# Comhairle Chontae Atha Cliath Theas

## Record of Executive Business and Chief Executive's Order

**Reg. Reference:** SD21A/0101      **Application Date:** 27-Apr-2021  
**Submission Type:** Clarification of      **Registration Date:** 19-Nov-2021  
Additional  
Information

**Proposed Development:** Residential development comprising a total of 28 apartments, in a building up to 4-storeys in height; the cumulative gross floor area is proposed to be 2,640sq.m on the 0.3157 hectare site including the site of the former filling station (0.2821 ha - under applicant's ownership) and a portion of land (0.0326ha) located to the north of the filling station site, where the existing traffic lights and pedestrian crossing are located along Nutgrove Avenue; to accommodate access to the site, it is proposed to relocate the existing traffic lights and pedestrian crossing which traverses both South Dublin County Council and Dun Laoghaire-Rathdown County Council boundaries; a development with a maximum height of c.11.7m and a total gross floor area of 2,640 sq.m comprising of 28 residential units comprising 8 1-bedroom apartments, 17 2-bedroom apartments and 3 3-bedroom apartments; communal am

#### Access Junction

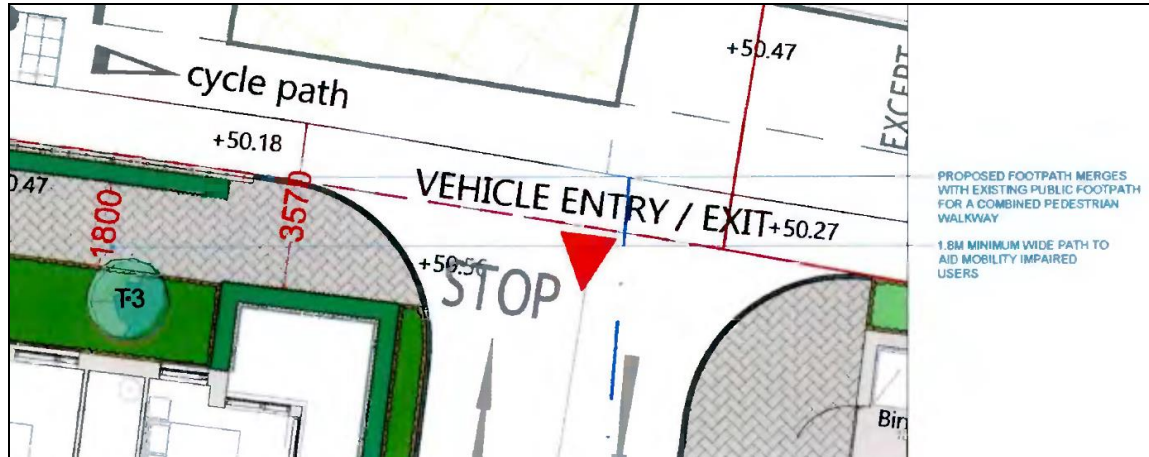
In relation to item 1(3) in particular, it is noted that the drawings submitted show a broad junction radius going through a full 90 degree turn within the site, inside the public footpath and cycle path (the cycle path here is curb mounted).

The applicant's proposal for the footpaths is to have a 3.57m footpath area but with segregation features (hedging) at the edge of the property boundary. This creates a parallel throughway within the site. Of particular concern is the risk that the private footpath may at a later stage be judged to require fencing and restrictive access points, which would detract significantly from the streetscape. It is considered more appropriate to provide a single, wider, footway at this location, without segregating features. It may be appropriate that this footway is taken in charge and adequate privacy strip provided. The applicant may wish to provide **clarification of additional information**.

- (a) The applicant notes that the TTA submitted in September was previously considered suitable in consultation with the Roads Department.
- (b) The applicant has proposed to provide for the footpath and tactile paving within the red line boundary. The applicant further suggests that works outside the red line boundary can be conditioned. The consulting engineers, Punch, have shown a revised layout to the junction, as well as a proposal for road markings, tactile paving and a pedestrian crossing at the site, with much of this outside the application red line boundary.
- (c) The applicant has proposed to replace the internal footpath with landscaping between the public footpath and front façade of the building.

The Roads Department has stated acceptance of the above submission. In relation to part (b), it is appropriate to condition works outside the red line boundary and there is no issue with these being delivered by the applicant as per the agreement of the Planning Authority. In relation to part (c), the revised layout is acceptable.
